DEVELOPMENT PLAN FOR
SECURITY FIRE STATION NO. 4
 0 Mesa Ridge Parkway
 Security, CO

FINAL LANDSCAPE PLAN

**RE: Request for Alternative Landscape Design.
Development plan: Security Fire Station No. 4**

SHEET NO. **LS-1**
 Sheet 1 of 2

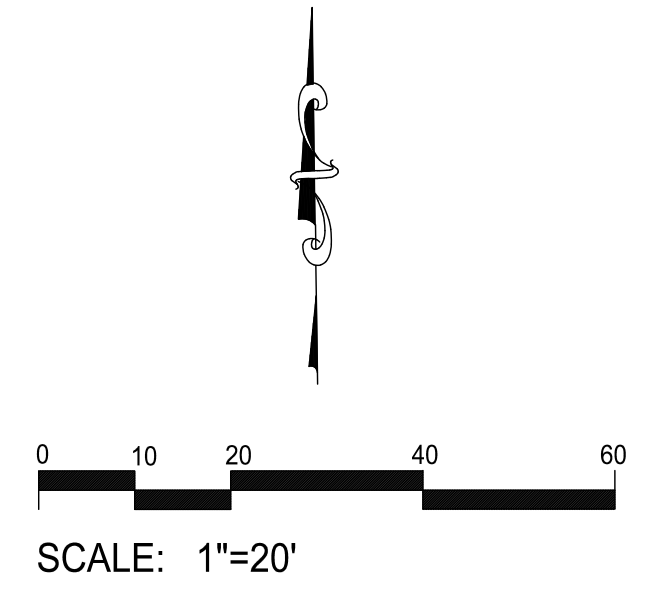
Trees need to be taken out of the right of way and planted on the property within the landscape buffer area.

Please explain. See also alternative landscape comment. Shrubs may only be replacements for trees for retail storefronts and only 1/2 of required trees may be replaced by shrubs.

Please provide justification in letter of intent and on this plan for alternative landscaping request. If criteria in LDC Sec. 6.2.2 regarding alternative landscaping cannot be met, please revise to provide the required number of trees.

This justification needs to be in letter of intent. Please review the criteria in Section 6.2.2 relating to alternative landscaping and justification requirements. Contact PCD Project Manager with questions.
